PLANS OF PROPOSED INTERSECTION IMPROVEMENTS
CORTEZ ROAD AT 43RD STREET WEST
BRADENTON, FLORIDA

MANATEE COUNTY PROJECT No: 307-6076861
FDOT PROJECT No: 437145-1

BID SET

INDEX OF ROADWAY PLANS

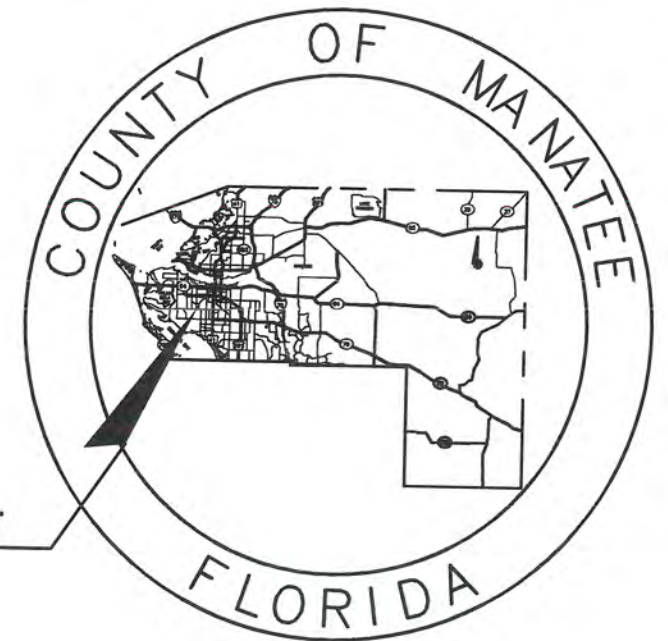
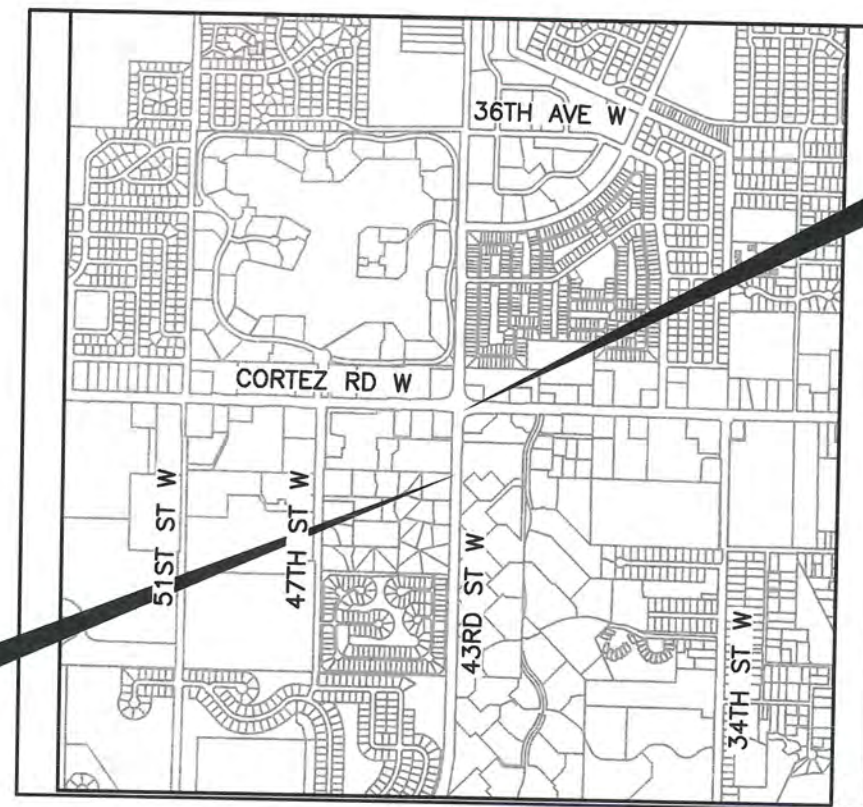
3-Key Sheet, Sheet 1, Suggest removing sheet 5 from the Index of Roadway Plans, it is already shown as sheet 2 in accordance with the FDOT Design Manual.

Response: Agree. Sheet 5 was removed from the Index of Roadway Plans.

INTERSECTION IMPROVEMENTS OF
CORTEZ ROAD AT 43RD STREET WEST
DRAINAGE MAP

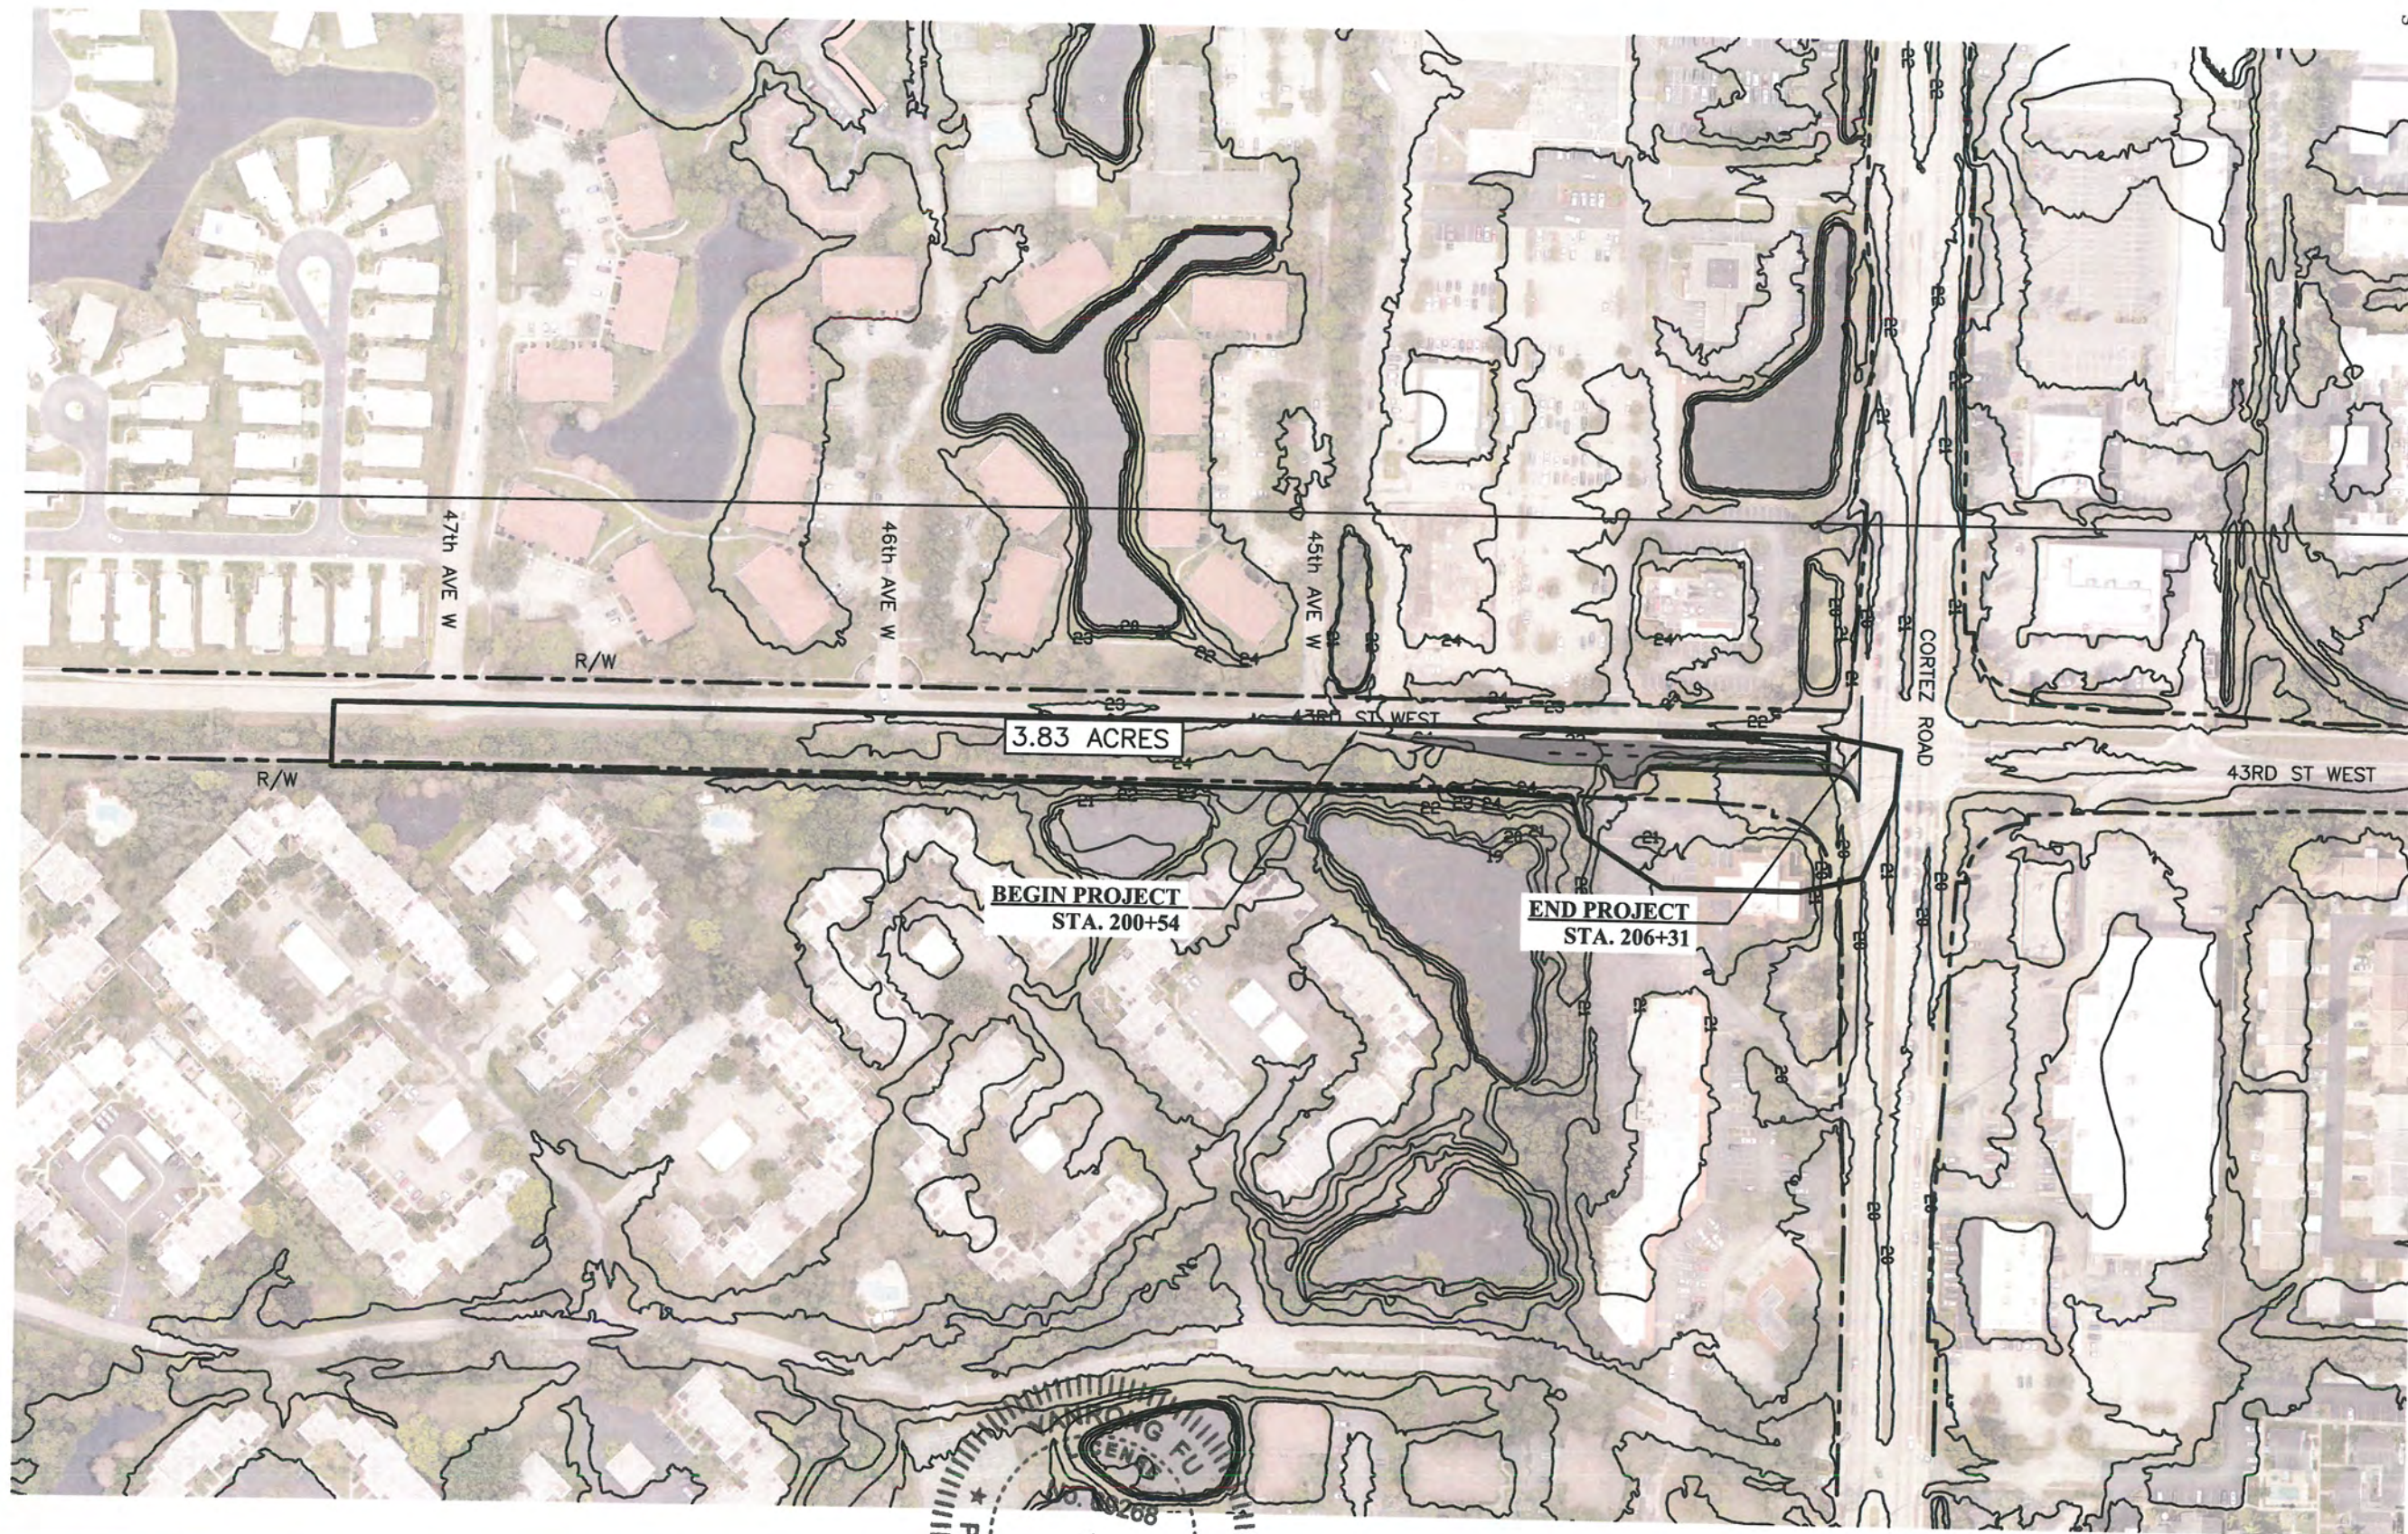
4-Drainage Map, Sheet 3, suggest adding begin and end project with stations.

Response: Agree. Begin and end project with stations were added on the Drainage Map.

INTERSECTION IMPROVEMENTS OF
CORTEZ ROAD AT 43RD STREET WEST
CROSS SECTION

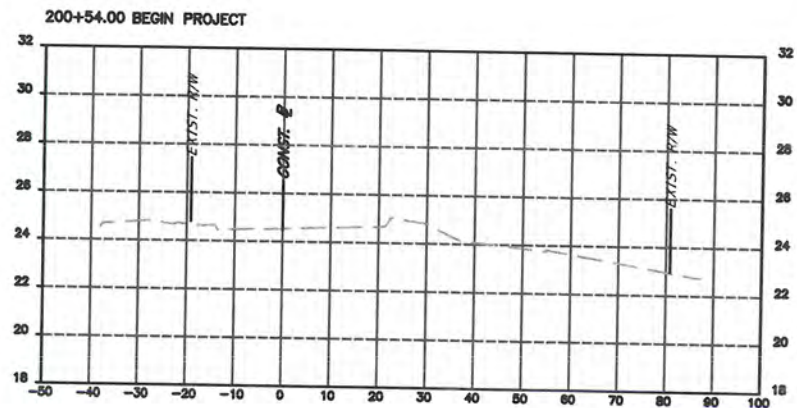
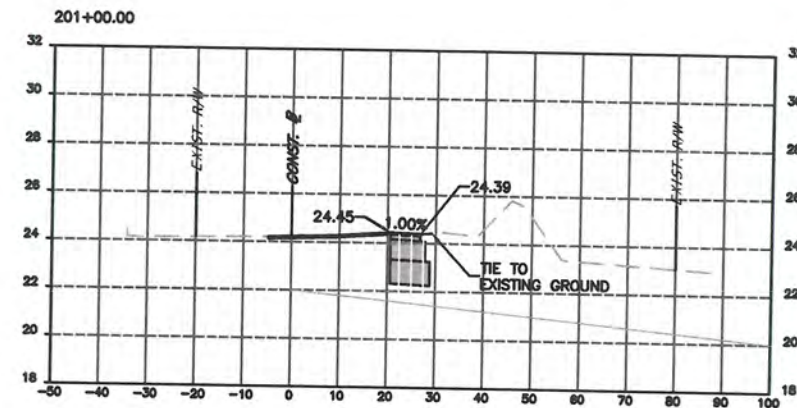
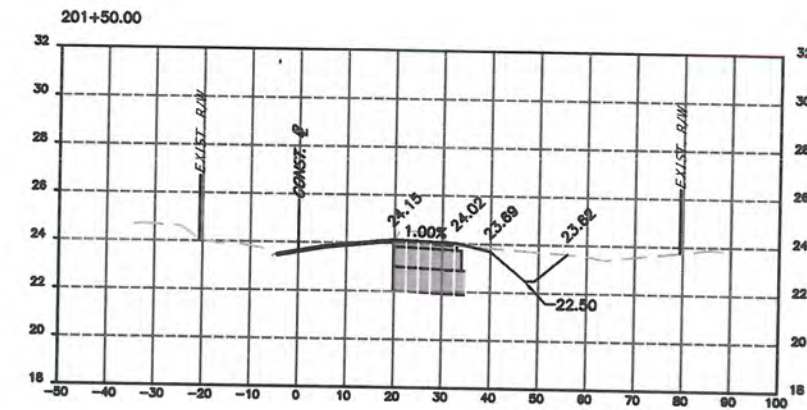
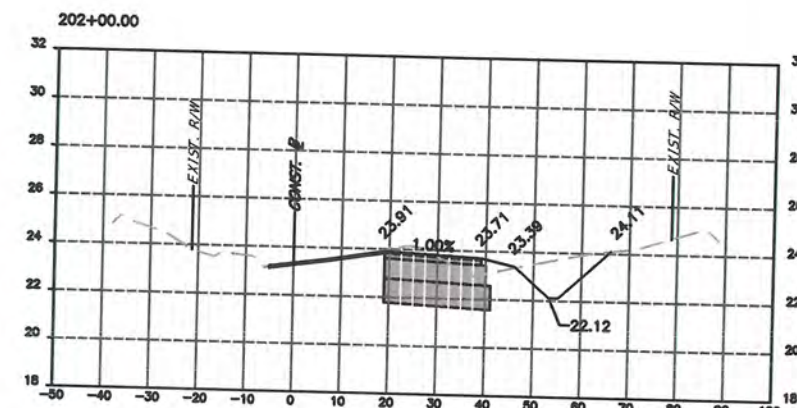
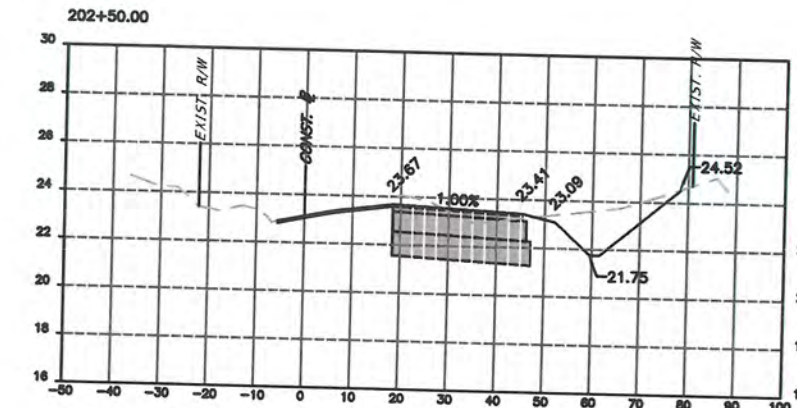
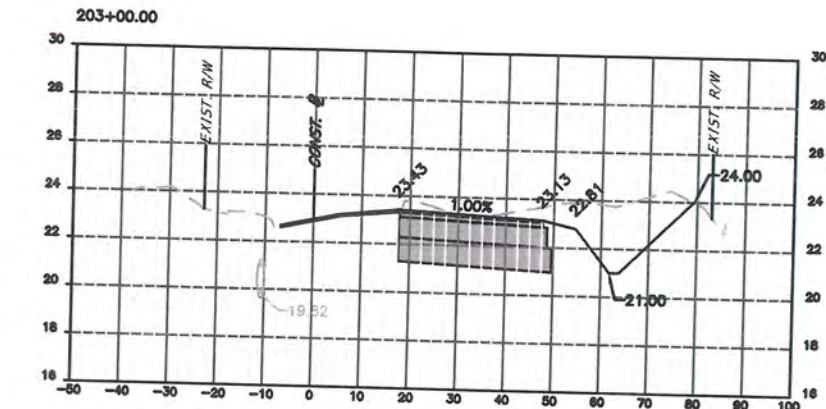
6-Cross Section, Sheets 10 & 11, Suggest adding Begin and End Project with stations.

Response: Agree. Begin and End Project with stations were added on the cross section sheets.
